15 September 2025

**Re: Global Stability Study for Eastern Slope near Building D
West Essex – Highlands Development
West Orange, New Jersey
Langan Project No.: 101049801**

As requested, in conjunction with the above-referenced study Langan Engineering and Environmental Services, LLC (Langan) has reviewed letters prepared by Princeton Hydro ("Princeton"), who has been retained by Objectors to the proposed Development. The Princeton letter, dated 16 July 2025, summarized their comments under four primary issues (below):

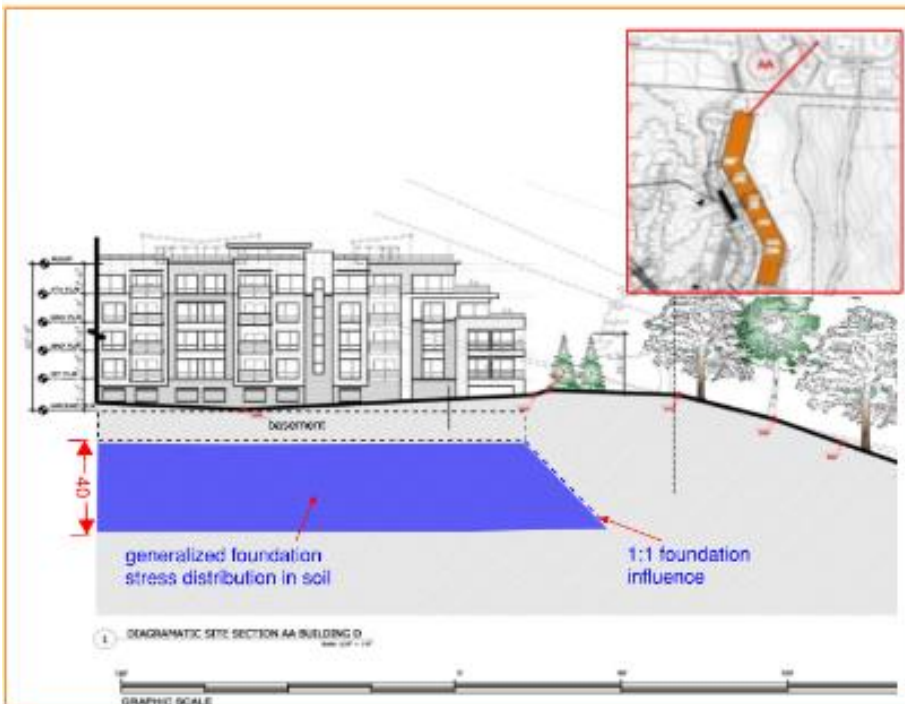
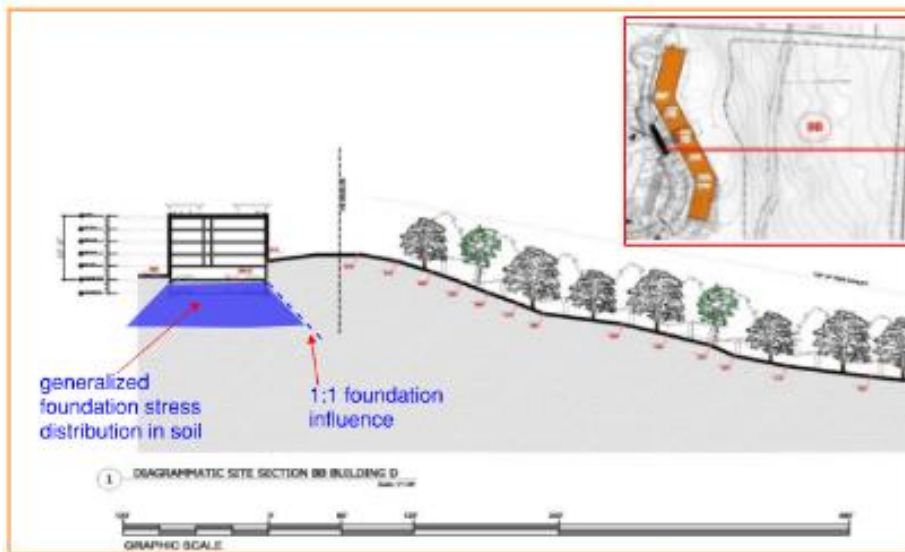
To make abundantly clear, our analysis demonstrates that the existing slopes are stable and that the new building does not change the loading condition on the slope; therefore, no change in the slope stability. Schematics below show the general area beneath the central and northern portions of the building where foundation loading occurs and will be distributed in soil. These schematics show the limited influence of the building loading, and specifically no influence on the slope.

Cross Section A (Static Condition)

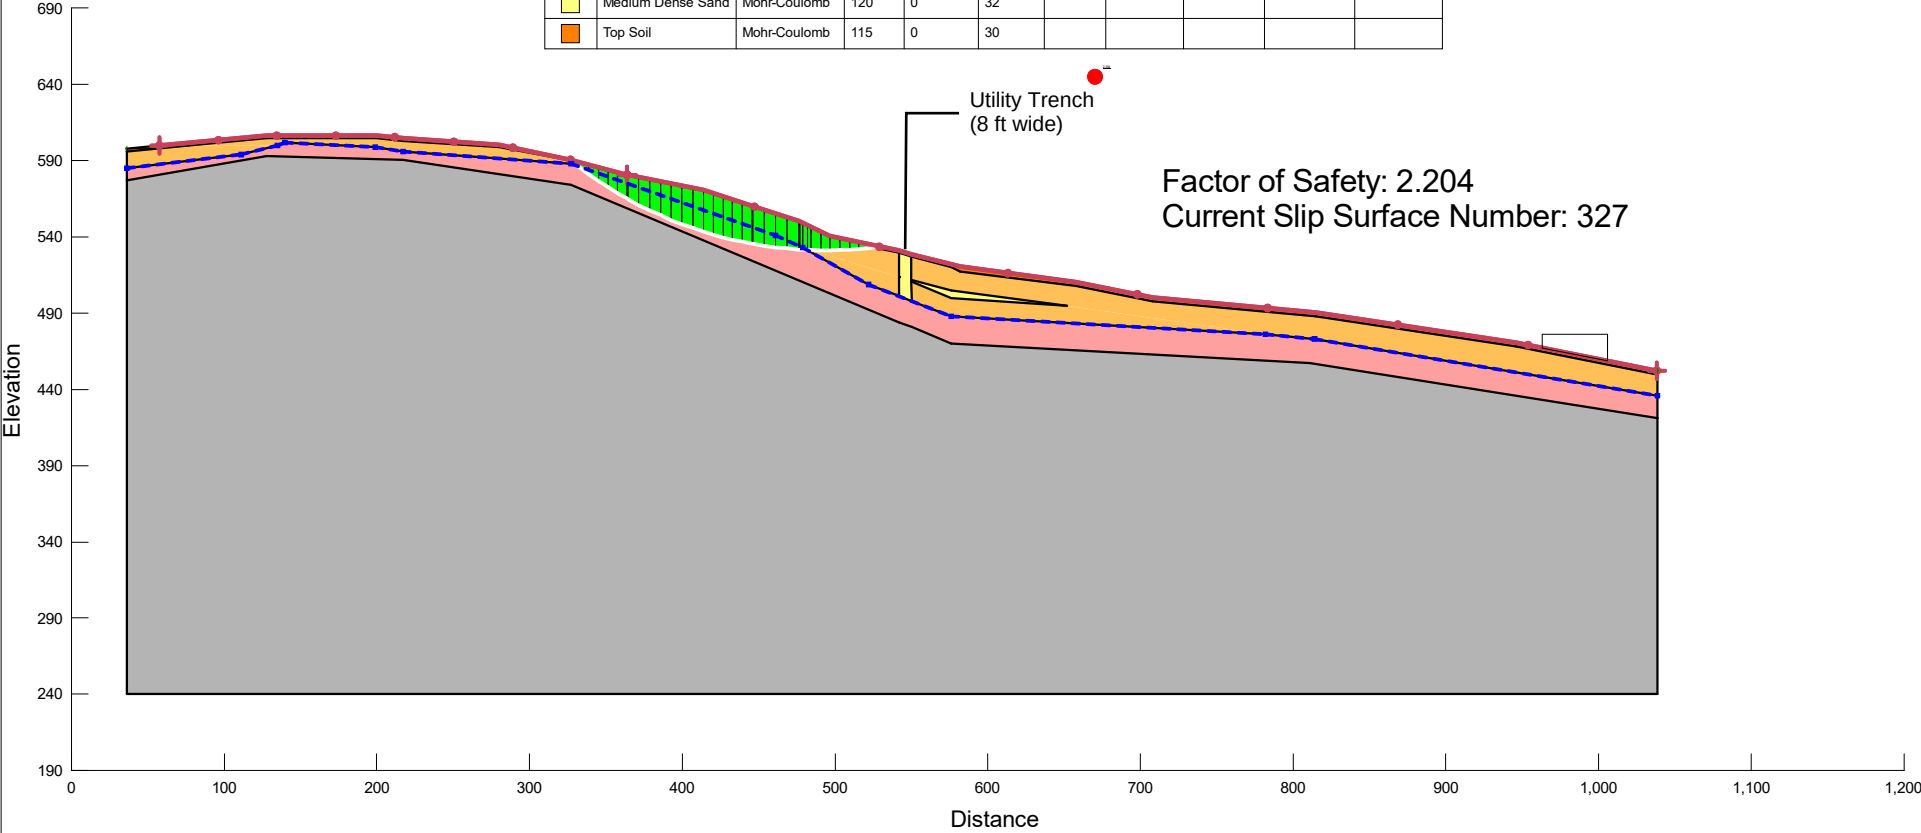
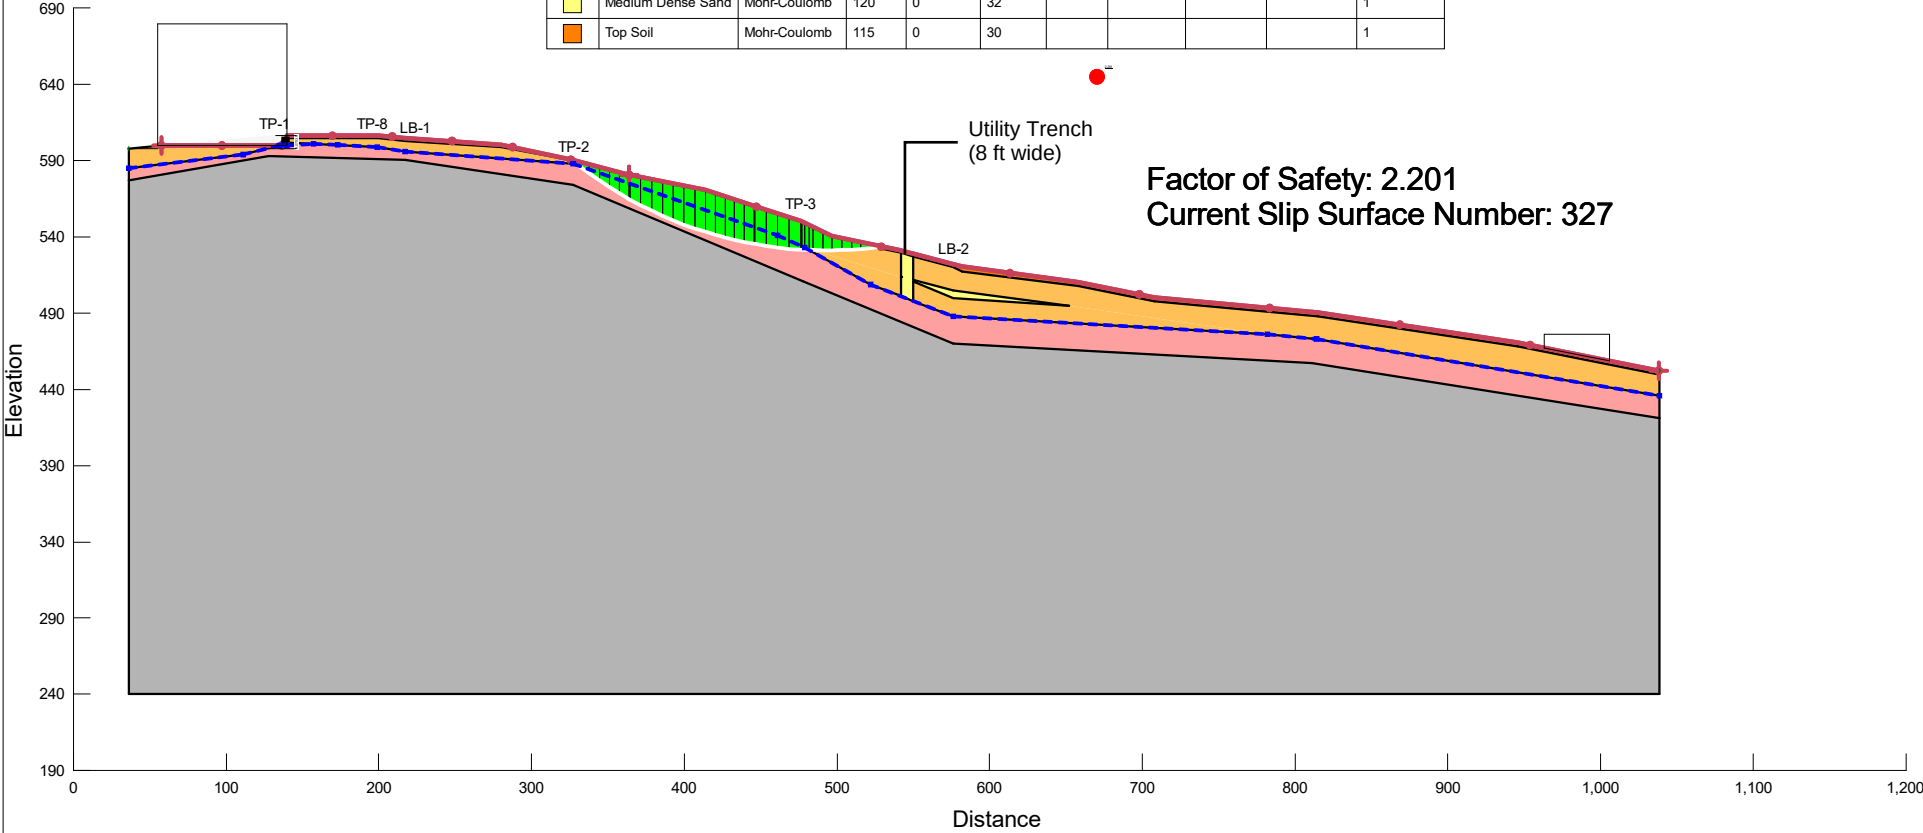
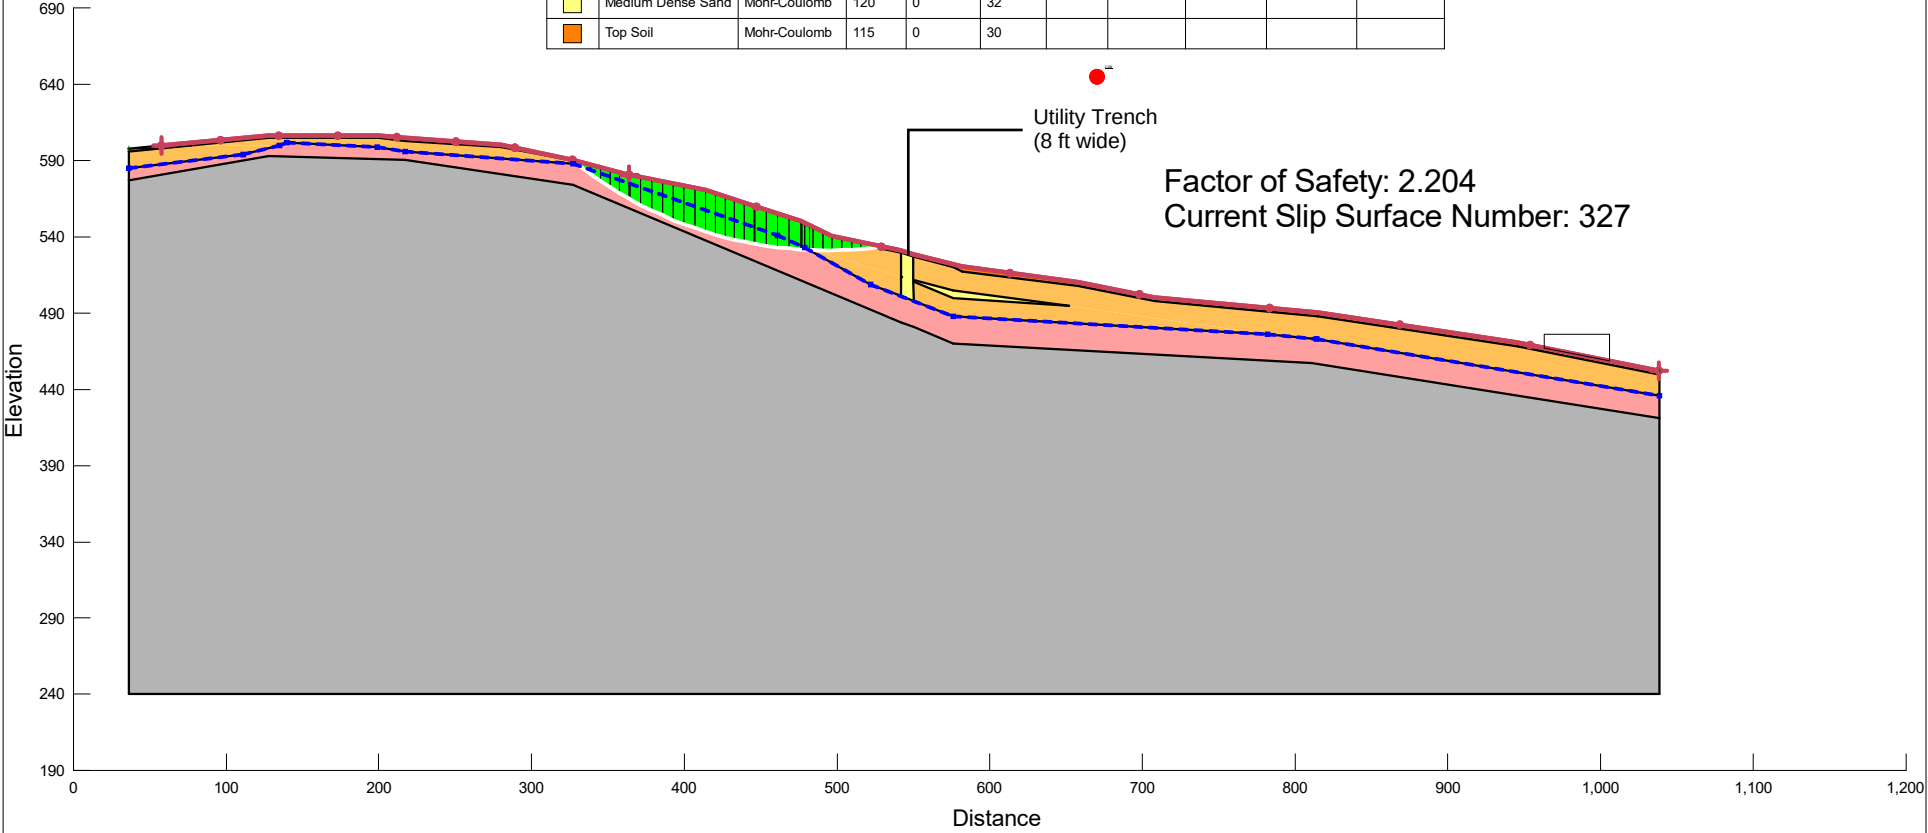
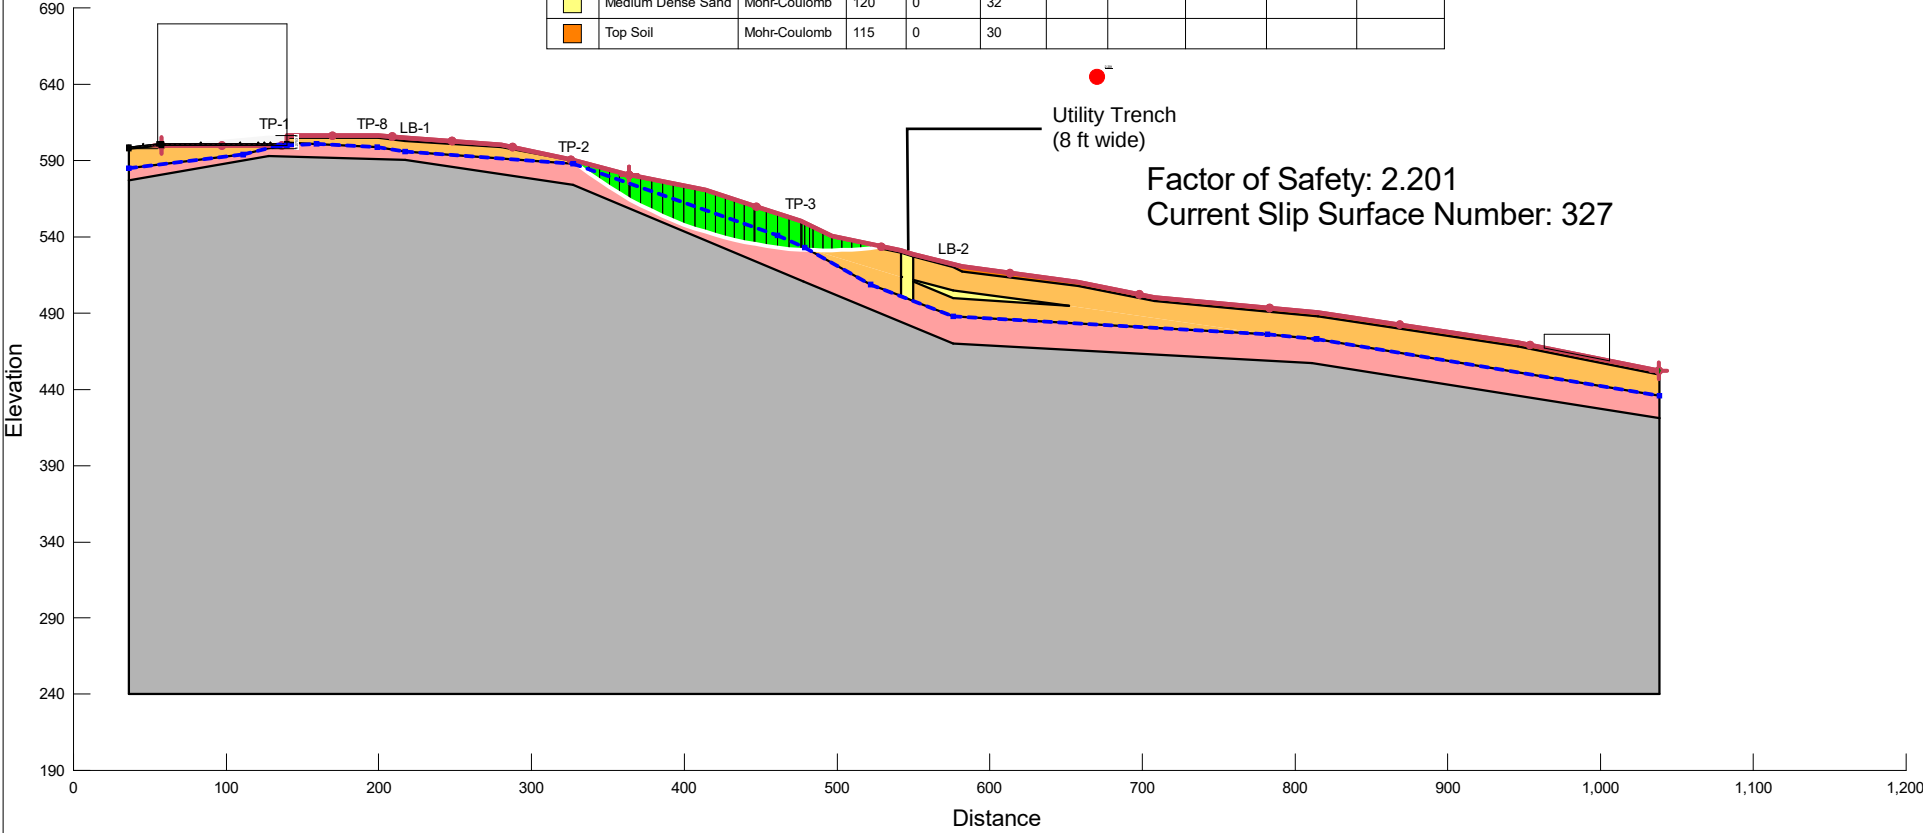
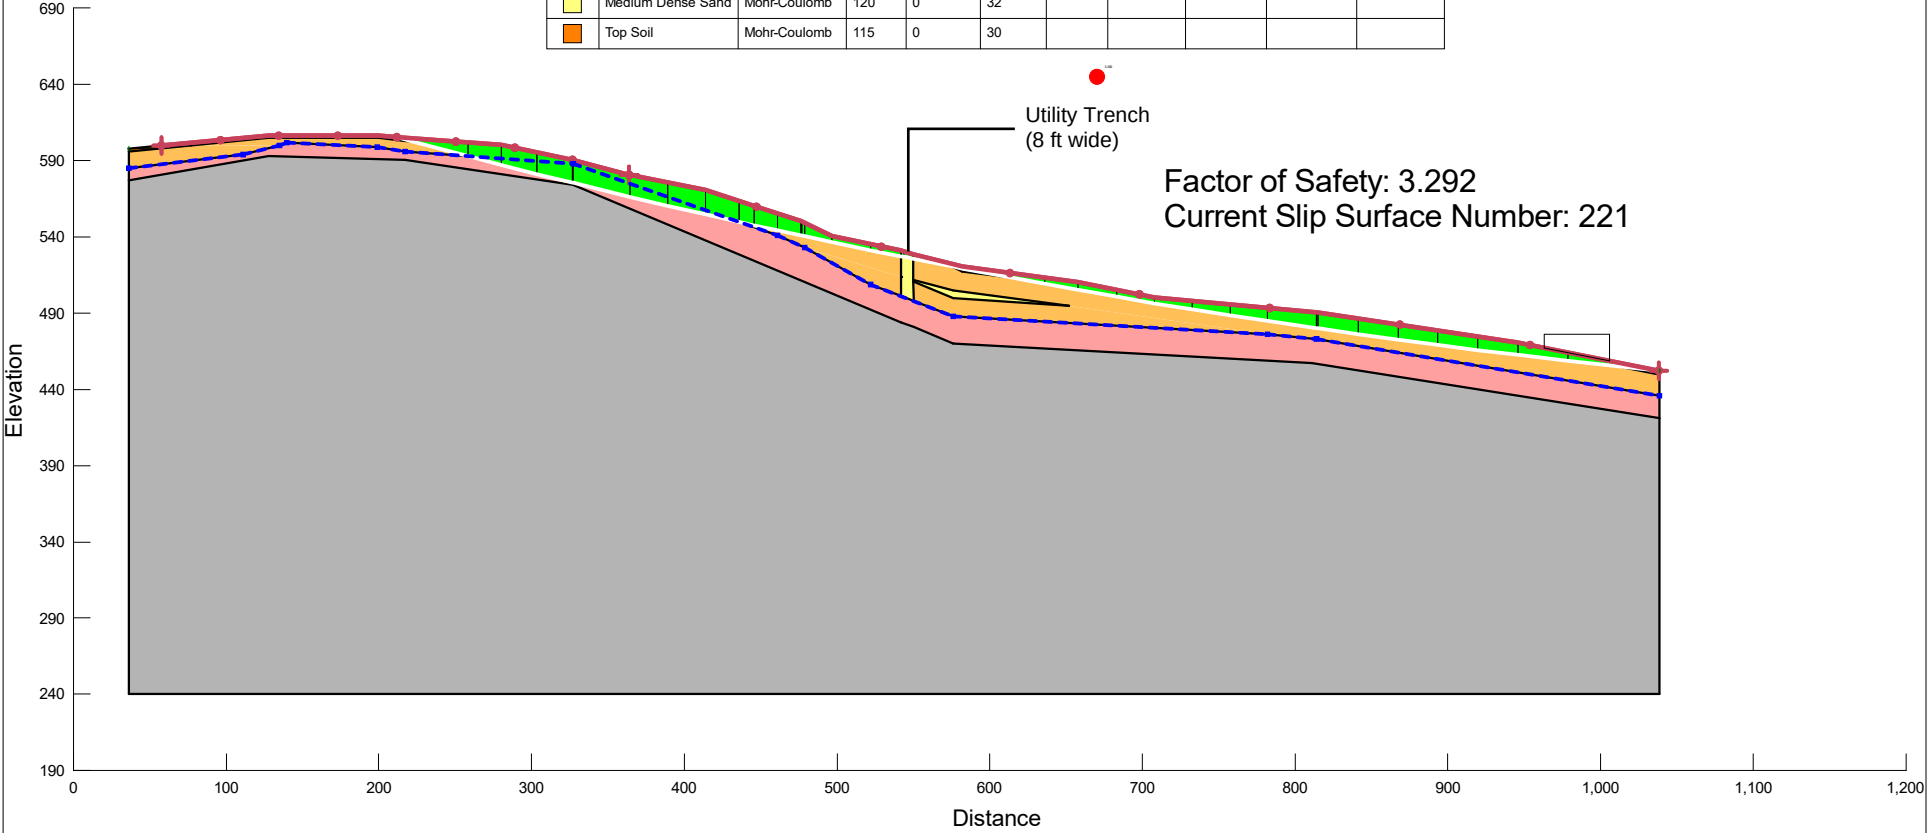
Langan Response: Princeton initially identified seven subparts associated with their position. Five of 7 relate to rock properties used in our model, one relates to building loading, and one relates to the presence of a sewer. In Princeton's 12 August letter they provided analyses using their interpretation of our data. Overall, Princeton repeatedly claims our design values are incorrect, yet they clearly misinterpret the data and mis-apply it.

We modeled our analysis sections A-A and B-B with the discontinuity of the wastewater utility line as a trench of medium dense sand having a friction value of 32 degrees extending from ground surface to the decomposed rock over 30 feet below the existing grade. Our models show that there is no change in the location of the critical failure surfaces or corresponding factors of safety (Exhibit B).
